BHARAT HEAVY ELECTRICALS LIMITED
PROJECT ENGINEERING MANAGEMENT, NOIDA

CORRIGENDUM- 14

PROJECTs	:	4 X 210 MW NTPC Kahalgaon- R&M (ESP)
PACKAGE	:	HVAC SYSTEM FOR R&M PROJECTS
ENQUIRY NO	:	PE/PG/NTK/E-6475/2020 Dated 16.07.2020
SUBJECT	:	TECHNICAL AMENDMENT + DUE DATE EXTENSION

AMENDMENT#3 TO EXISTING CLAUSES OF TECHNICAL SPECIFICATION

SCHEME FOR AIR COOLED DUCTABLE SPLIT UNIT FOR MODIFIED ESP CONTROL ROOM BUILDING UNIT-1 (TYPICAL)

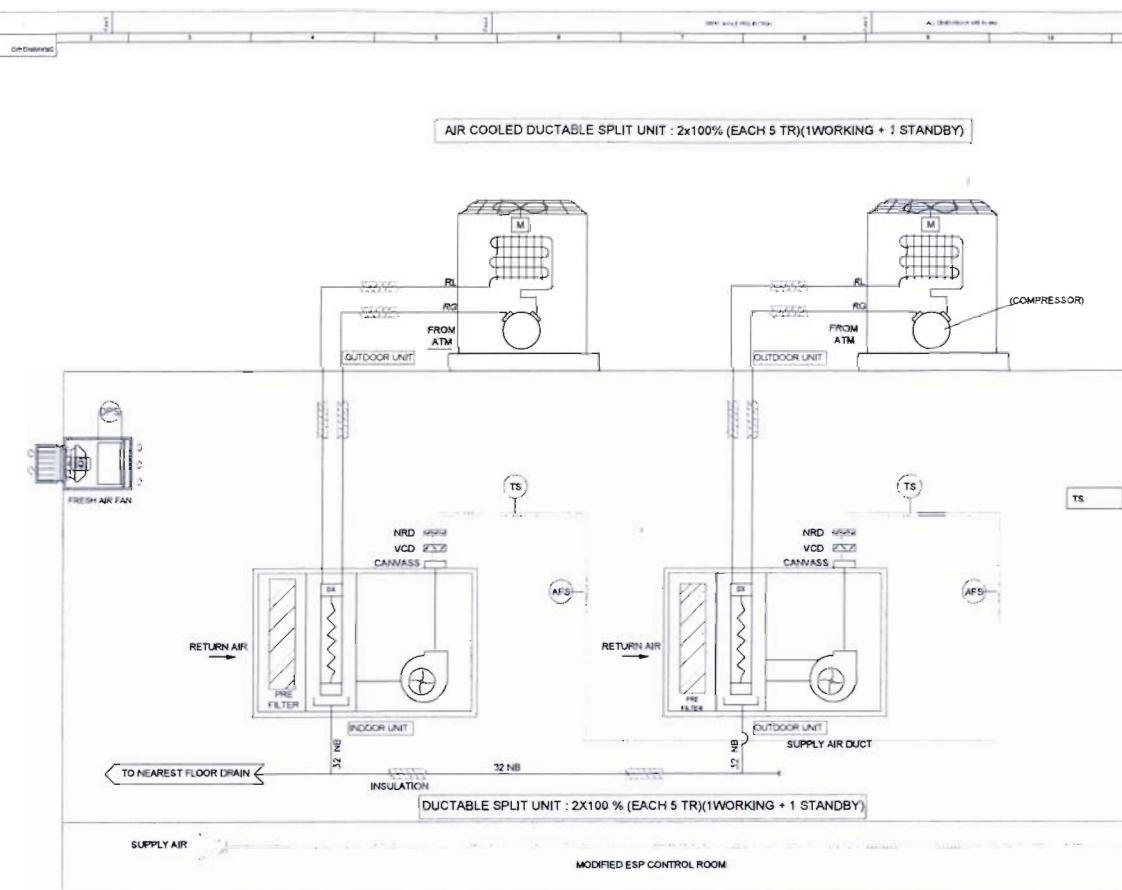
Sl. No.	Clause	Existing description	To be read as (Amendment)
1.	Clause 02.01.01 Page 8 of 277	Two (2 nos.) Air cooled Package AC (1W+1SB) of 15 TR Capacity, along with indoor and outdoor units, piping, insulation, cabling, etc. for the AC area.	Two (2 nos.) Air cooled Ductable Split AC(1W+1SB) of 5 TR Capacity(Actual) , along with indoor and outdoor units, piping, insulation, cabling, etc. for the AC area.

The Ductable split A/C unit shall have one condenser (outdoor) unit and one Evaporator (indoor) unit to suit the control rooms. The capacity (TR) of the indoor unit shall be the actual capacity (100%) as the split units are intended to be used. Outdoor units shall comprise of compressor, cooling fan, condenser. Indoor unit comprising of blower, filter, cooling coil shall be mounted in attractive, corrosion resistant enclosures. The compressor shall be of hermetic scroll / rotary type. The contractor shall indicate the safety measures provided for the compressor and motor. The condenser shall be air cooled copper coil with Aluminium fins type with ample condensing surface. The cooling coil shall be of direct expansion type with copper tubes and mechanically bonded aluminium fins; it shall be sufficiently deep for effective cooling. The refrigerant circuit between (outdoor) Condenser unit and (indoor) Evaporator unit shall be carried out
